Limerick Generating Station, Units 1 and 2  
Renewed Facility Operating License Nos. NPF-39 and NPF-85  
NRC Docket Nos. 50-352 and 50-353

SUBJECT: License Amendment Request  
Proposed Changes to Technical Specification Surveillance Requirements for  
Emergency Diesel Generator Frequency and Voltage Tolerances and for  
Emergency Core Cooling System Pump Flows (Implementing WCAP-17308)

**Subject: License Amendment Request  
Proposed Changes to Technical Specification Surveillance  
Requirements for Emergency Diesel Generator Frequency and  
Voltage Tolerances and for Emergency Core Cooling System Pump  
Flows (Implementing WCAP-17308)**

**LGS 480V Distribution System Simplified Diagram**

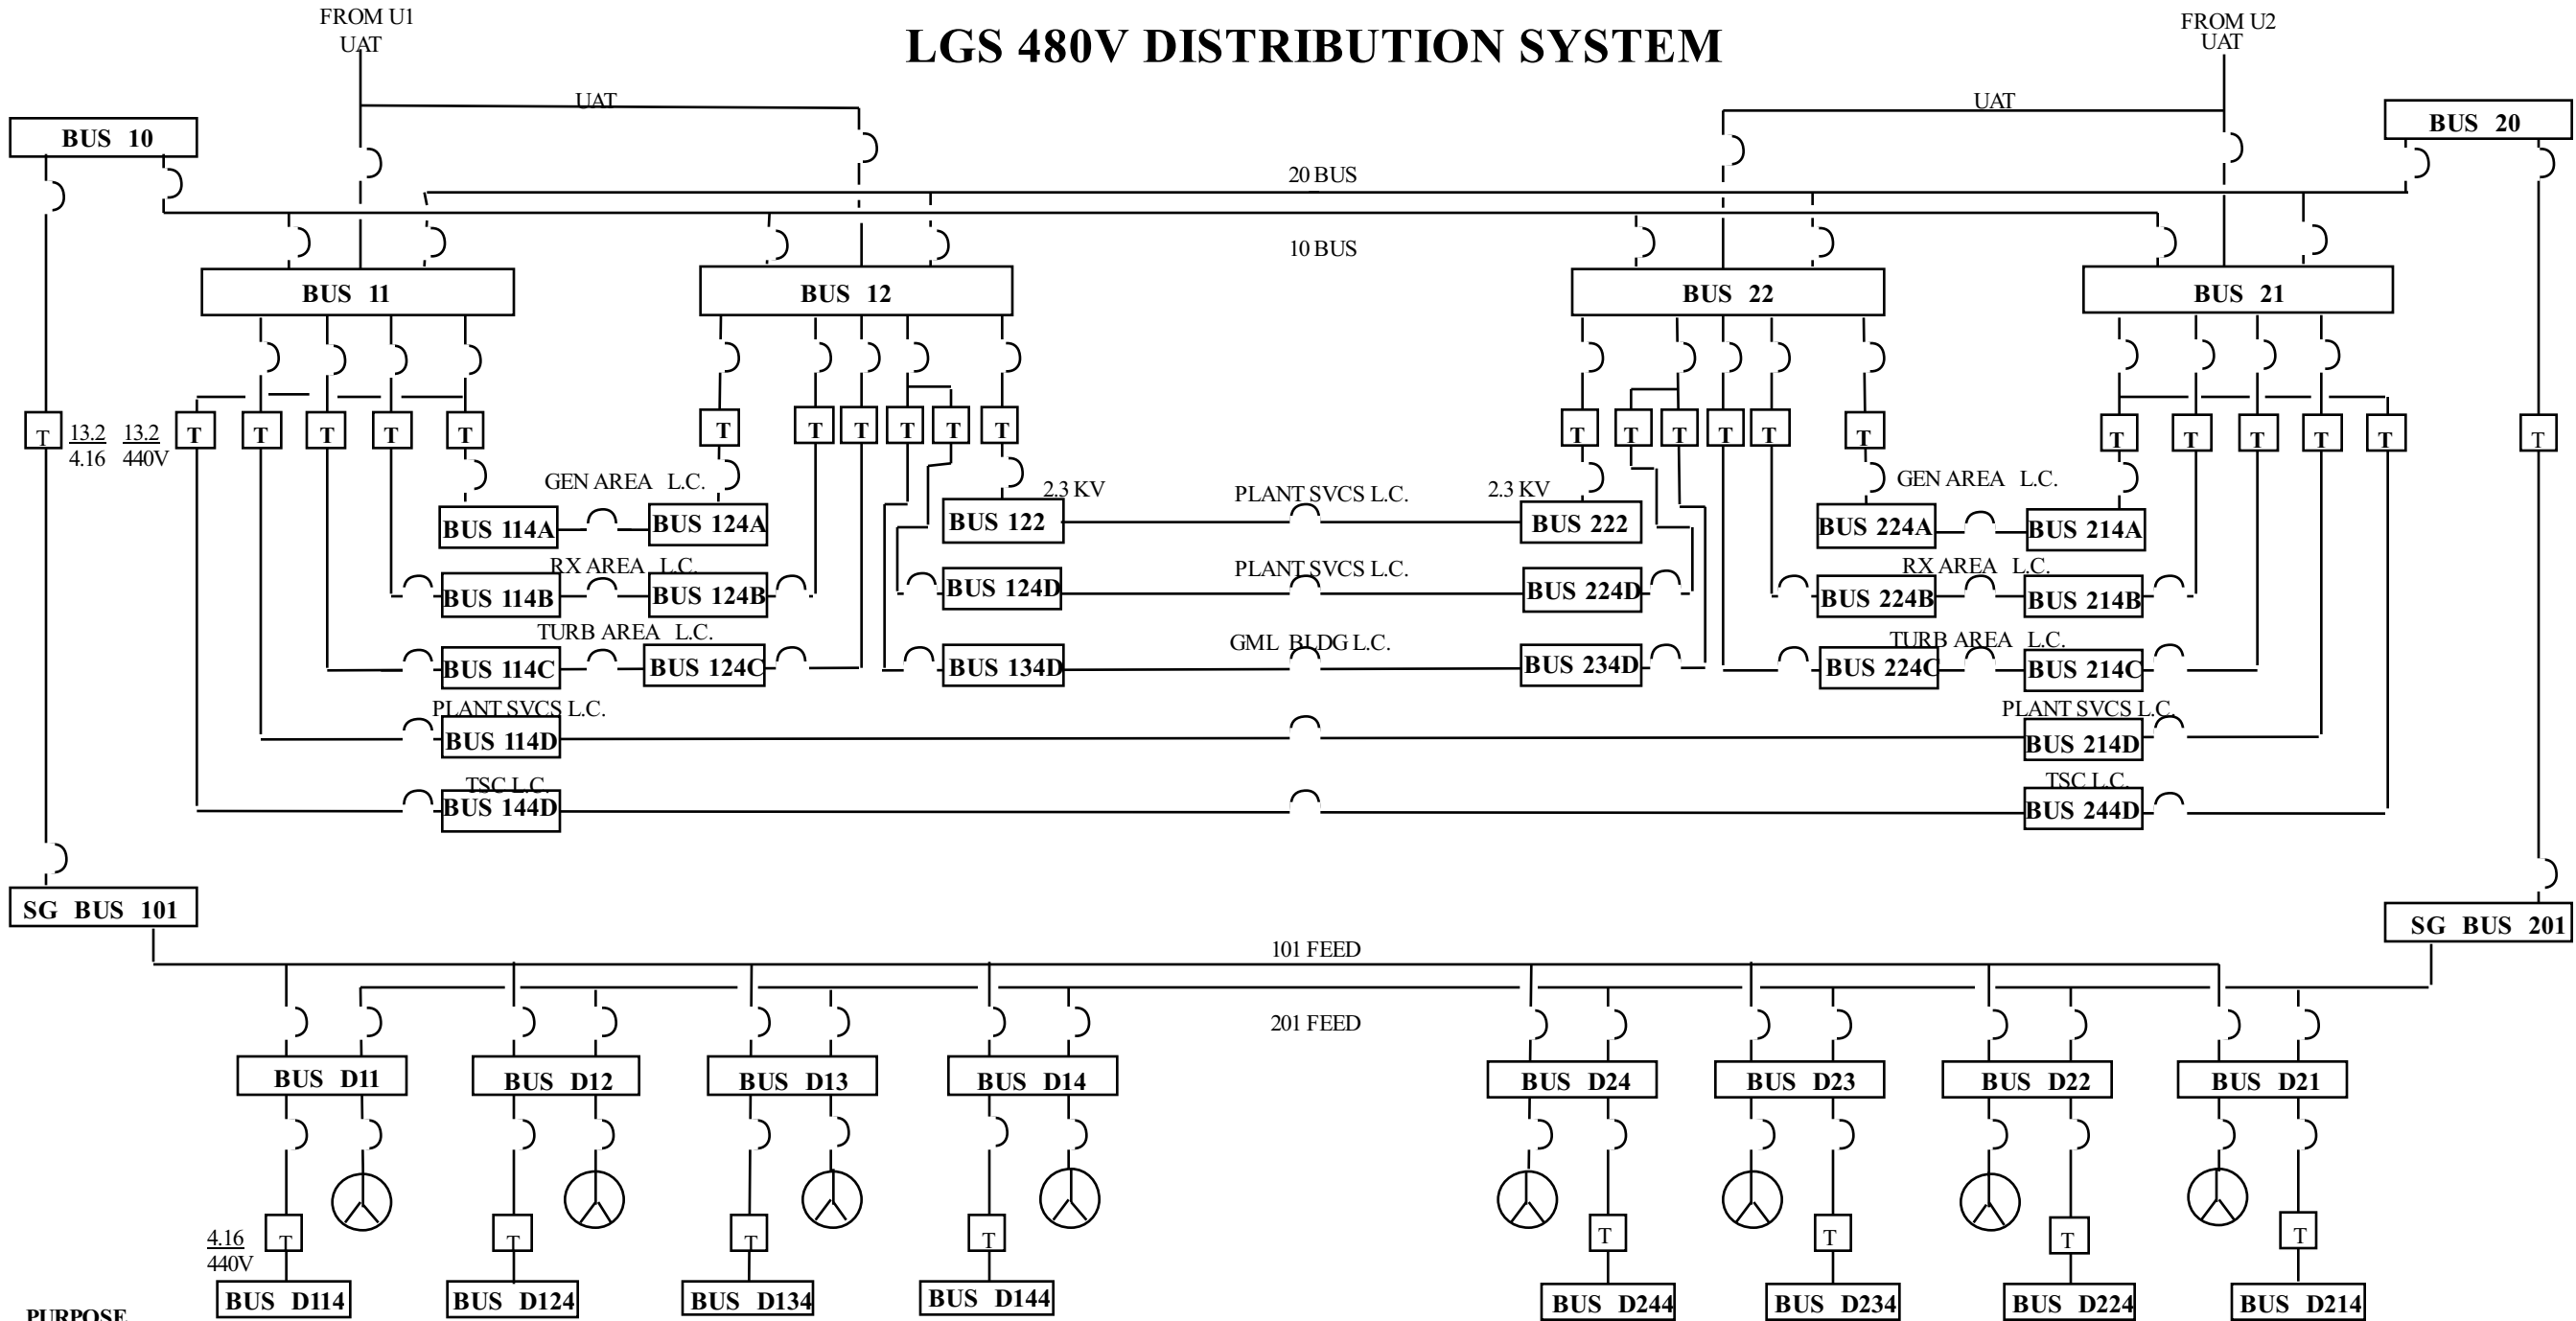
- 1) A typographical error in Unit 1 TS 3/4 .8.3.1.8.b will be corrected. The 480-VAC load center identified as “D224 (20B204)” will be revised to “D244 (20B204).” In Attachment 8, it can be seen that the safeguard 480 load center fed from the D24 4.1 kV emergency bus should be labeled D244 consistent with the labeling nomenclature established for the 480 VAC safeguard load centers.
- 2) A typographical error in Unit 1 TS 4.8.1.1.2.e.2 will be corrected. The “c)” had been erroneously inserted into the middle of the TS 4.8.1.1.2.e.2.b wording as could be clearly seen in the equivalent Unit 2 TS 4.8.1.1.2.e.2.b, which is correct.

A typographical error in Unit 1 TS 3/4 .8.3.1.8.b will be corrected. The 480-VAC load center identified as “D224 (20B204)” will be revised to “**D244** (20B204).”
